[Lot 4] AIXM-498 Revision of the Approach Type list of values

ID:	AIXM-498
target version:	AIXM 5.2
version:	1.0
last updated:	24 JUN 2021
status:	PROPOSED

The UML class diagram to the right shows the modified list of values:

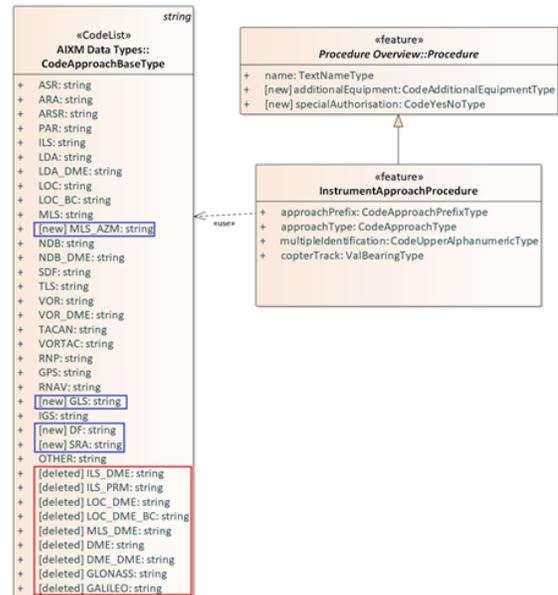
- In the **InstrumentApproachProcedure** class update the definition of the **approachType** to read “The component of the procedure identifier that indicates either the ground-based navigation system used for the final approach segment (usually limited to the system used for lateral guidance), or an indication that it is an RNP or (legacy) RNAV approach.”
- In the **CodeApproachBaseType** list of values make the following changes:
 - add SRA = Surveillance Radar
 - add MLS_AZM = Microwave Landing System - Azimuth Only
 - add DF = High frequency direction-finding (VDF) station
 - add GLS = GBAS Landing System
 - modify LOC = Localizer *only*
 - modify RNAV = Area Navigation (*not PBN*)
 - remove ILS_DME
 - remove ILS_PRM
 - remove LOC_DME
 - remove LOC_DME_BC
 - remove MLS_DME
 - remove DME
 - remove DME_DME
 - remove GLONASS
 - remove GALILEO
